**JOINT REGIONAL PLANNING PANEL
(Sydney East)**

JRPP No	2016SYE037
DA Number	16/9
Local Government Area	City of Botany Bay
Proposed Development	Integrated Development Application, requiring approval from the NSW Department of Primary Industries - Water pursuant to the Water Management Act 2000, for a mixed use development containing five buildings of between 7 to 8 storeys. The development comprises two levels of basement car parking, residential apartments, serviced apartments, ground floor retail premises and childcare centre.
Street Address	200 Coward Street, Mascot
Legal Description	Lot 1 DP 701026
Applicant	Karimbla Constructions Services (NSW) Pty Ltd
Owner	Karimbla Properties (No. 36) Pty Ltd
No. of Submissions	Ten (10) in opposition
Regional Development Criteria	Development with a CIV of \$105,959,235
List of All Relevant s79C(1)(a) Matters	• Environmental Planning & Assessment Act 1979, Part 4 – Development Assessment • Environmental Planning & Assessment Regulation 2000, Part 6 – Procedures relating to development applications • State Environmental Planning Policy (Infrastructure) 2007 • State Environmental Planning Policy No. 55 – Contaminated Land • State Environmental

Figure 12 Proposed Shadow diagrams - original design vs amended design - 10am

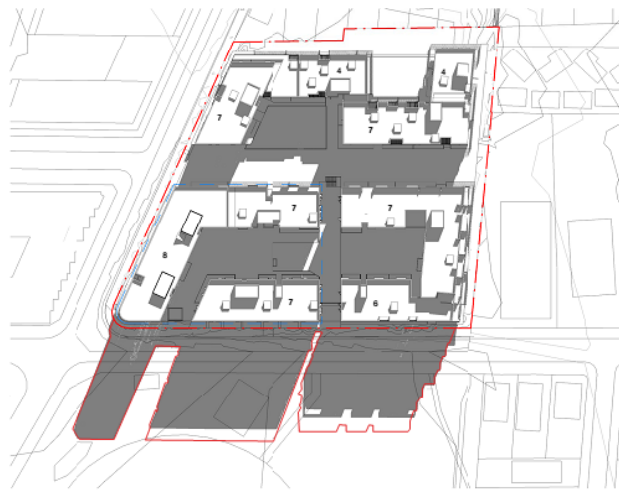
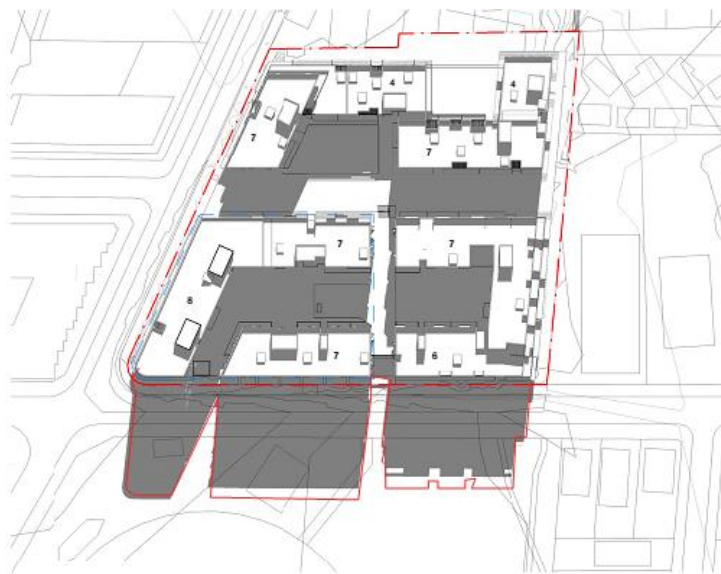
The alternative design has provided for the deletion of one level from each of the two buildings with their longest sides fronting Coward Street. The shadow diagrams provided below depict the impact of the design amendment on the overshadowing to the park, with the line indicating the original proposal, and the shaded area indicating the amended design.

Critically, the amended shadow diagrams indicate that the passive recreation space at Lionel Bowen Park will continue to receive relatively good solar access in midwinter, particularly during the lunchtime period of 11am to 2pm. Council estimates that the average shadow cast to the area of Lionel Bowen Park between 11am and 2pm in midwinter will be approximately 10%. The estimated area of shadowing at 12pm, is represented in a 3D perspective image shown below.

Figure 18 Estimate of overshadowing to Mascot Park and Lionel Bowen Park at 12pm at the winter solstice

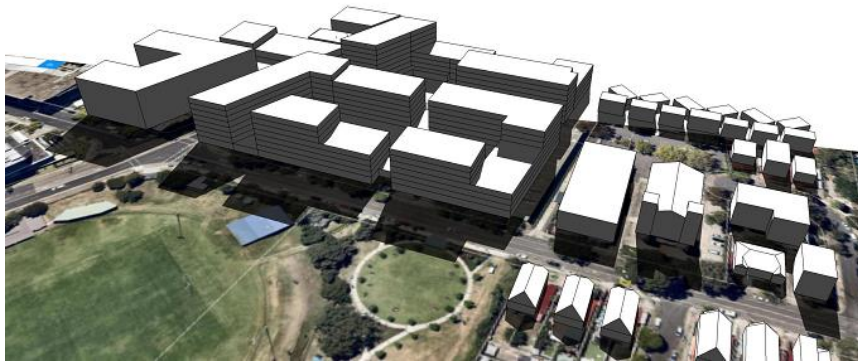
The amended scheme is generally consistent with the requirements of Part 9A. However, the amended design provides for an improved retention of solar access to the public park which sits opposite, and the proposal is considered satisfactory in this regard.
